Resolution of Ashfield Council 8 July 2014

That in respect of the proposed May 2014 amendment to the 2012 Concept Plan Application, for the land at 2-32 Smith Street Summer Hill, the Council advise the Department of Planning and Infrastructure that:

Subject	2-32 SMITH STREET, SUMMER HILL CONCEPT PLAN APPLICATION AMENDMENT
File Ref:	SC684
Prepared by	Col Colot - Senior Strategic Planner & Projects
Reasons	Respond to State Department of Planning & Environment
Objective	Response to Proposed Amendment to 2012 Concept Plan Approval

Figure 3 –Proposed 2014 changes to the 2012 Concept Plan Approval regarding building heights in relation to number of storeys.

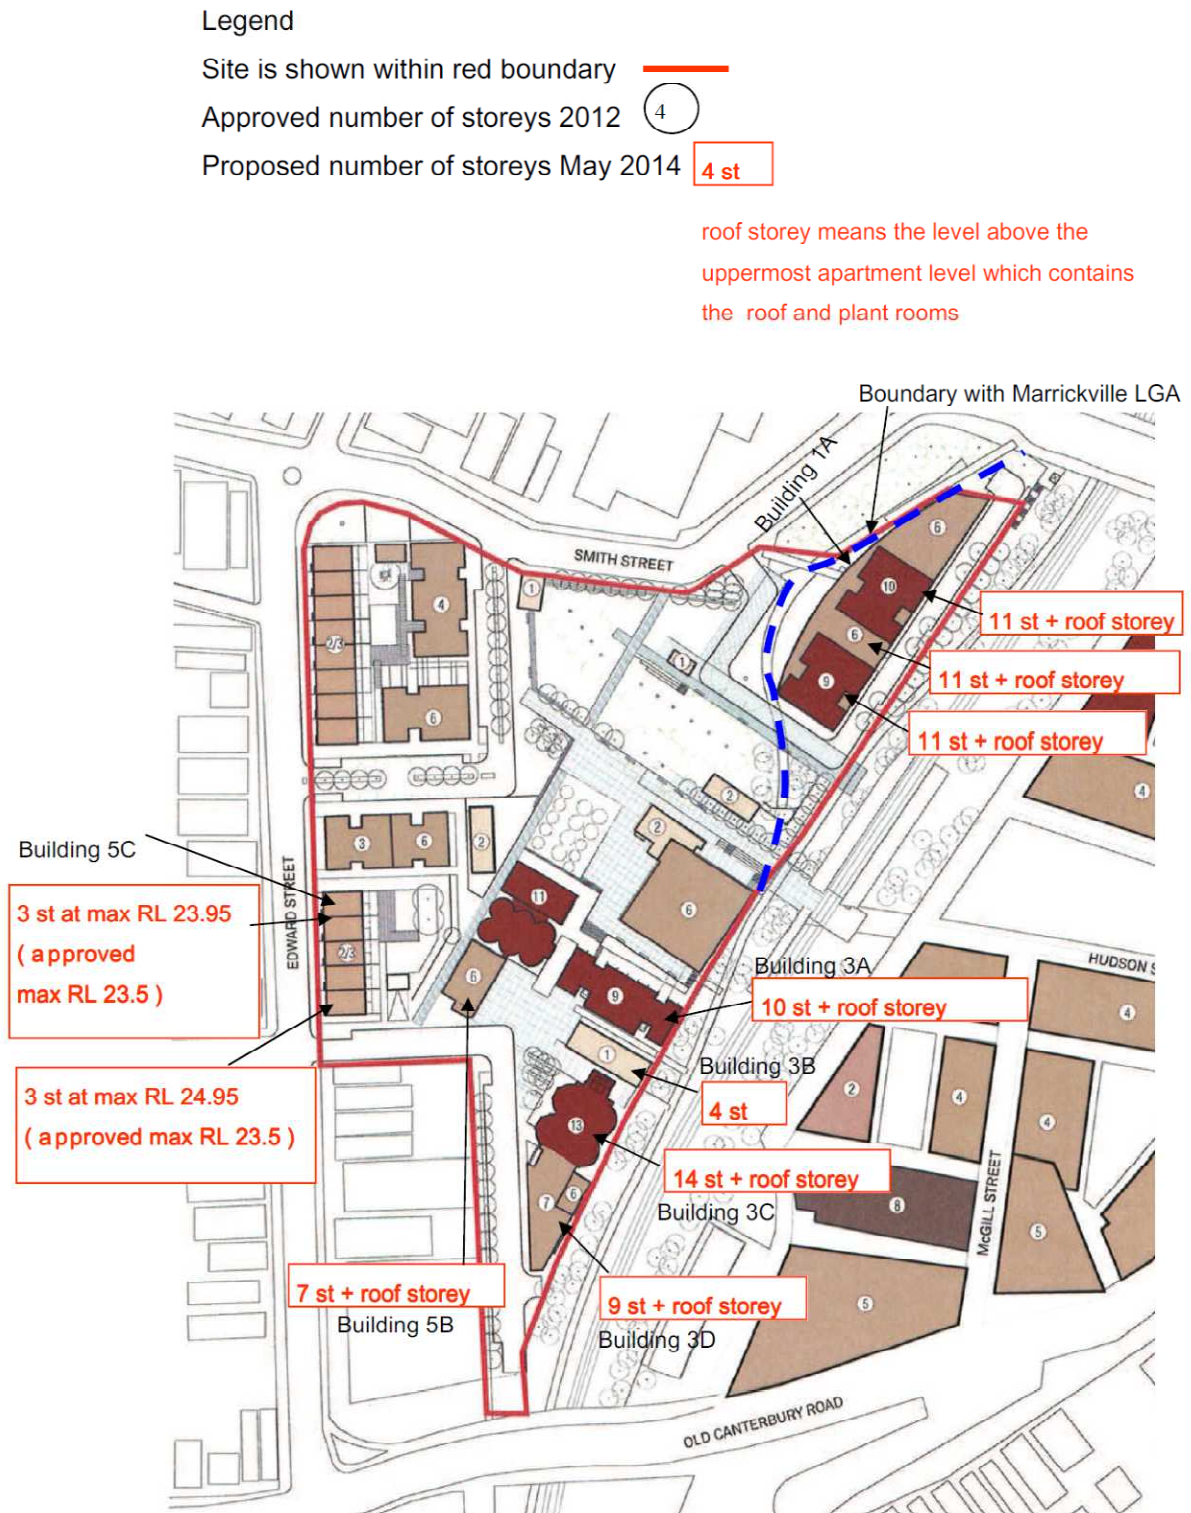
The location of proposed increases in building height for particular buildings is marked up in **Figure 3**.

As shown in **Attachment 3** and its extract in Figure 5 below (produced by Council officers), the increase in building height for Building 5B from 6 storeys to 7 storeys will have visual impacts for dwellings along Edward Street, including from their rear gardens, and also for houses in Spencer Street from their rear gardens. Increase in height within Stage 3 for Buildings 3A, 3C & 3D (to the rear of Building 5B) will also have a similar affectation.

Council's position should be that it objects to any increase in building bulk and height for Buildings 5B, and Buildings 3A and 3D, given the adverse visual impacts for nearby residential areas in Summer Hill.

View from rear garden of house in Fleet Street

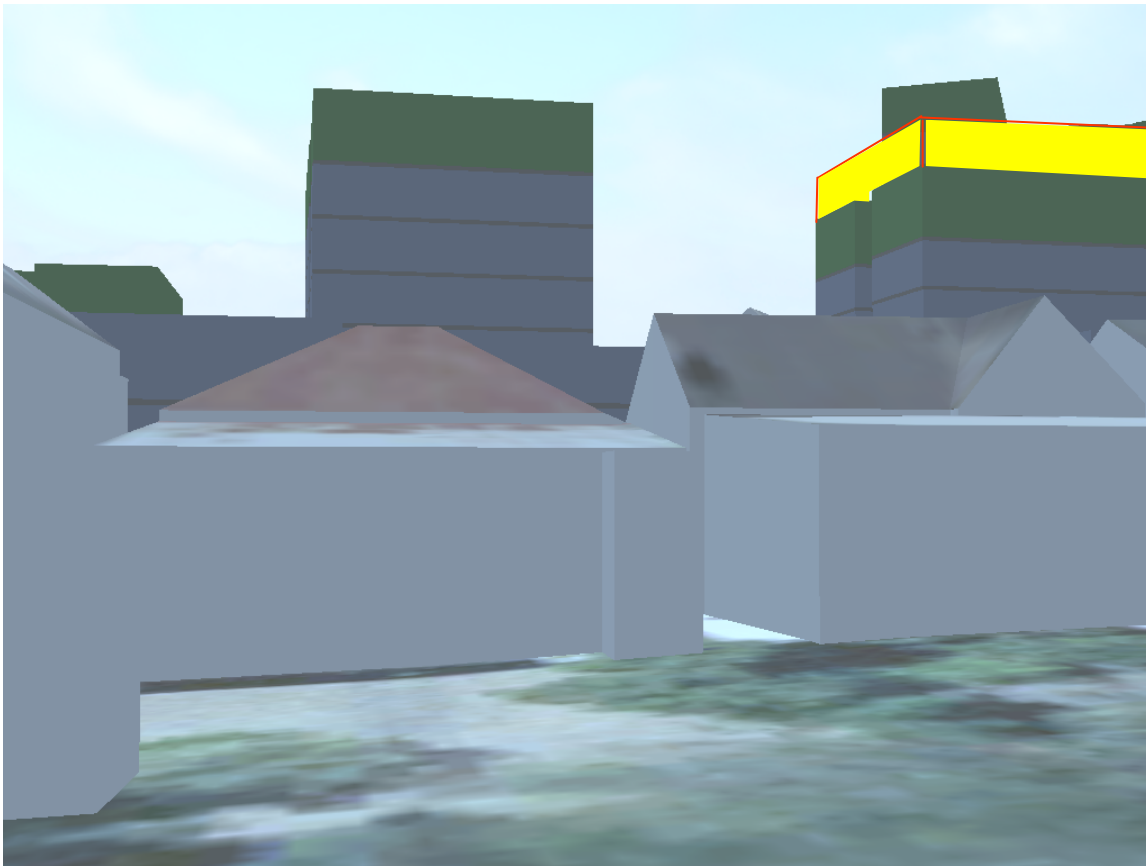
Council's position should be that it objects to any increase in building bulk and height for Building 1A given the adverse impacts for nearby residential areas in Summer Hill, including those in Chapman Street and Fleet Street.

- require the applicant to submit drawings which show how many apartments can be accommodated within the 2012 approved Building 1A building envelopes in Stage 4.
- require the applicant to explain the Gross Floor Area that can be contained within the 2012 approved Building 1A building Envelopes in Stage 4.
- evaluate the increase in bulk and height for Building 1 A and to report this impact in a detailed manner as required by the Director General requirements using modelling equal to SIMURBAN.
- stipulate a maximum FSR to apply for the site boundaries within Stage 4 within the Marrickville site, in order to provide certainty, and avoid any future request for variations seeking to clarify the approval conditions.
